Final Statement of Reasons for Rulemaking
Including Summary of Comments and Agency Response

**PROPOSED GREENHOUSE GAS (GHG) REGULATIONS FOR MEDIUM- AND
HEAVY-DUTY ENGINES AND VEHICLES, OPTIONAL REDUCED EMISSION
STANDARDS FOR HEAVY-DUTY ENGINES, AND AMENDMENTS TO THE
TRACTOR-TRAILER GHG REGULATION, THE DIESEL-FUELED COMMERCIAL
MOTOR VEHICLE IDLING RULE, AND THE HEAVY-DUTY HYBRID-ELECTRIC
VEHICLES CERTIFICATION PROCEDURES**

Public Hearing Date: December 12, 2013
Agenda Item No.: 13-11-1

October 21, 2014

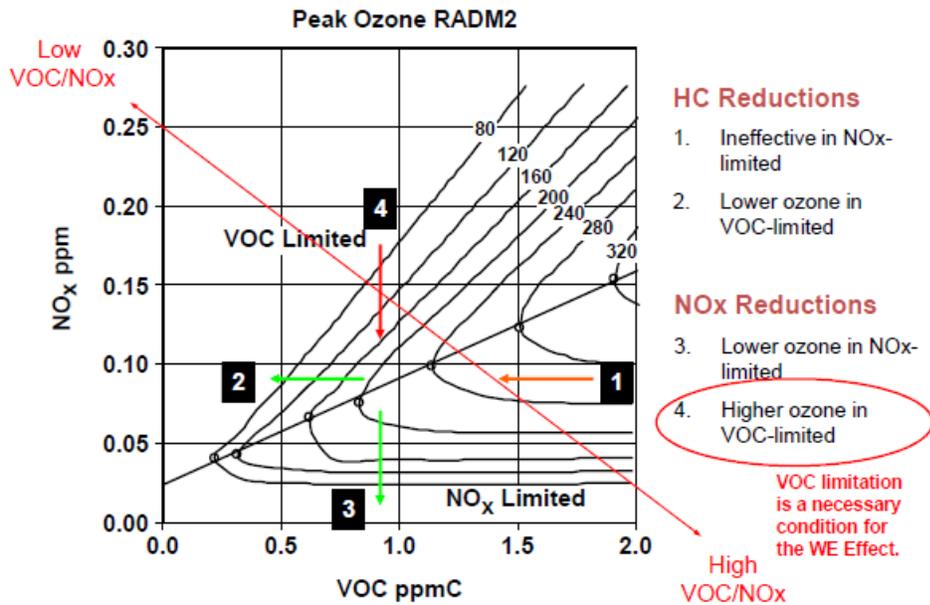
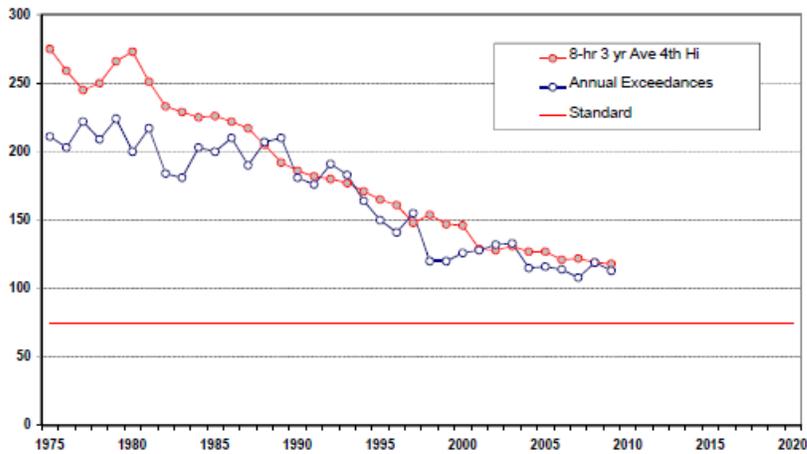
8. Comment: Although the low NOx standards are presented as an optional program to reduce NOx (and thereby ozone emissions), there is nonetheless an underlying assumption, confirmed by CARB Staff, that these voluntary standards are likely to be proposed as mandatory standards, and that such mandatory NOx reductions would yield corollary reductions in ambient ozone levels. Two key factors impact the validity of that assumption: the projection of future atmospheric NOx emissions levels; and the modeling of how those NOx emission level interact chemically with Volatile Organic Compounds ("VOC") concentrations to form ozone. The first of those factors is typically estimated and projected through ARB's EMFAC model. It has been some time since ARB has held workshops to review the inputs to EMFAC, especially with respect to those inputs that most heavily determine future emissions levels (e.g., malfunction rates and deterioration). EMA would appreciate an opportunity to review the estimates of heavy-duty vehicle population growth, average VMT/vehicle, the change in deterioration factors, rates of tampering and malfunction, rebuild practices for future model years, 'zero hour' gram per mile emission rates, as well as other factors for the future heavy-duty vehicles that most influence future emission levels. Accordingly, EMA requests that ARB provide a forum for the detailed review of those key emission inventory factors.

The second aspect of this modeling effort – assessing how NOx emissions interact chemically with VOC levels to form ozone – is typically estimated utilizing the Community Multiscale Air Quality ("CMAQ") Model. Critical to the results of that type of modeling is whether the regional atmosphere at issue is "NOx-limited" or "VOC-limited." In a VOC-limited environment (i.e., where lower VOC/NOx ratios prevail), marginal decreases in NOx can actually cause increases in ozone.

Figure 3

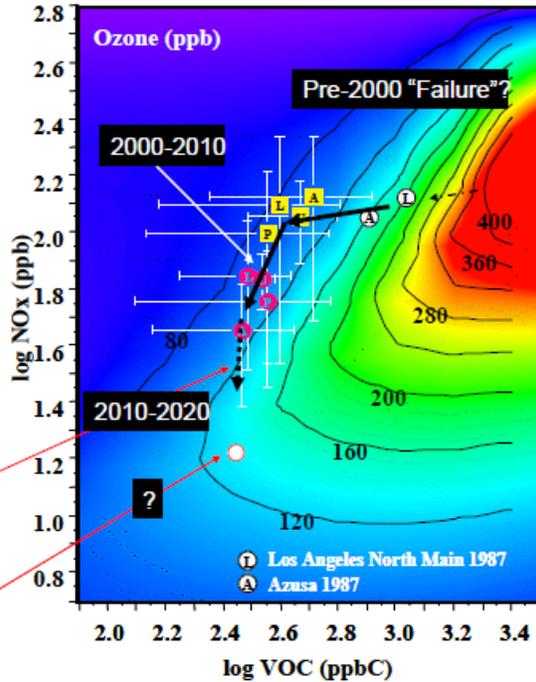
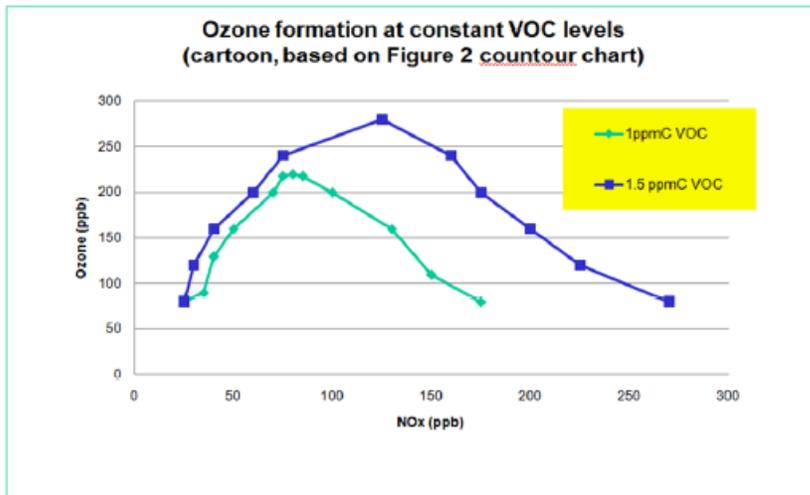
To reduce ozone in SoCAB, future reductions in NO_x must be accompanied by reductions in VOC.

2010 to 2020 projected reductions in VOC of ~10% and NO_x of ~40%.

70% NO_x reduction near ridgeline

Ozone is a function of NO_x and VOCs (not NO_x alone)
